STAFF REPORT

SUBJECT: FP-2021-0007
Daphne Square Final Plat

LOCATION: 4700 W. McMillan Rd.
NE corner of N. Black Cat Rd and W.
McMillan Rd.

B. Final Plat (date: 2/14/2021)

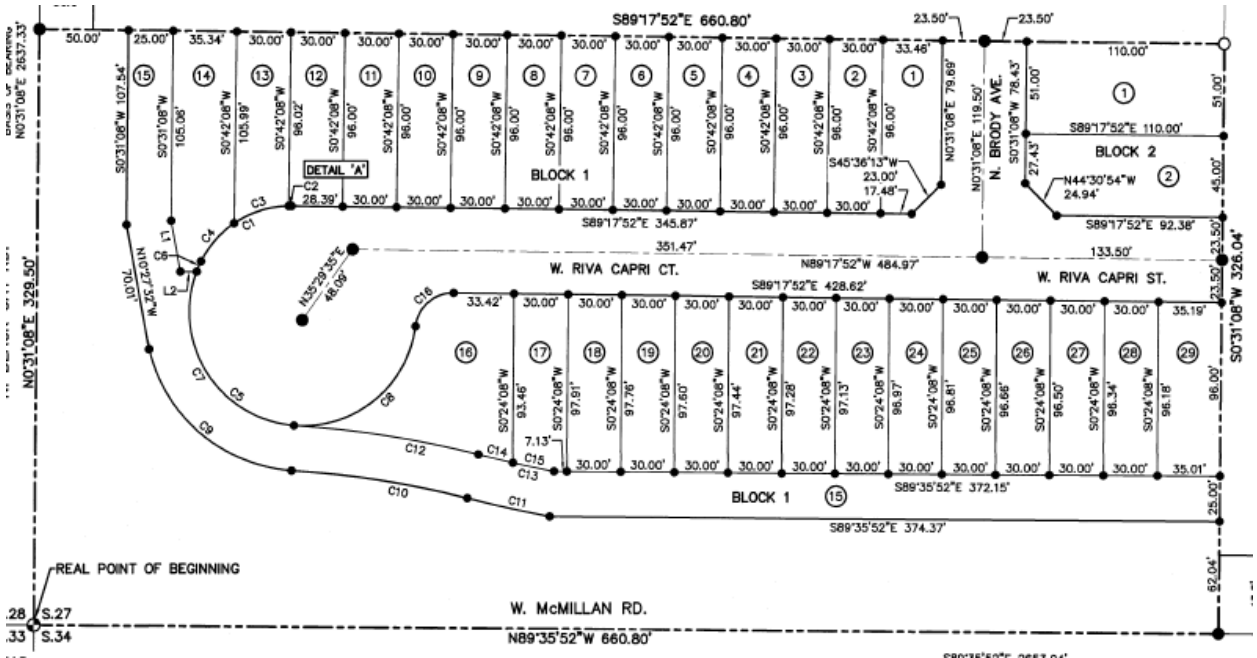
3. Prior to City Engineer signature on the final plat, the final plat prepared Idaho Survey Group LLC, stamped by Gregory G Carter, dated: 02/14/2021, included in Section V.B shall be revised as follows:

- a. Add "City of Meridian" to Note #2.
 - b. Add Lot 2, Block 2 to Note # 5.
 - c. Add a note which states "Rear setbacks of all homes in Lots 1-14, Block 1 shall be 20 feet. "

G. Final Plat Landscape Plan (date: March 1, 2021)

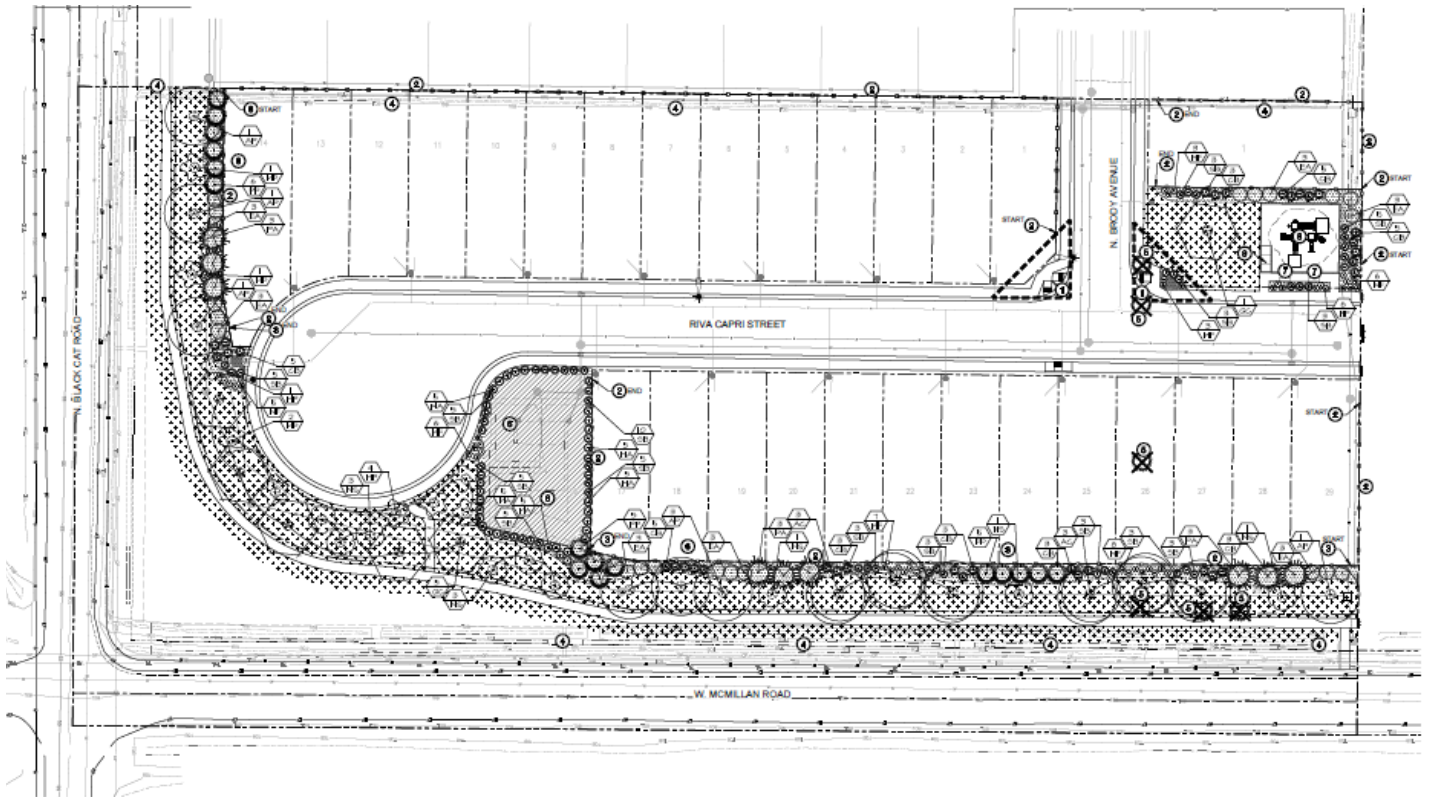
4. The landscape plan prepared by Breckon Landscaping, stamped by Jon Breckon on March 1, 2021 is approved as submitted.
5. Future development shall be consistent with the R-15 dimensional standards listed in UDC Table 11-2A-6.
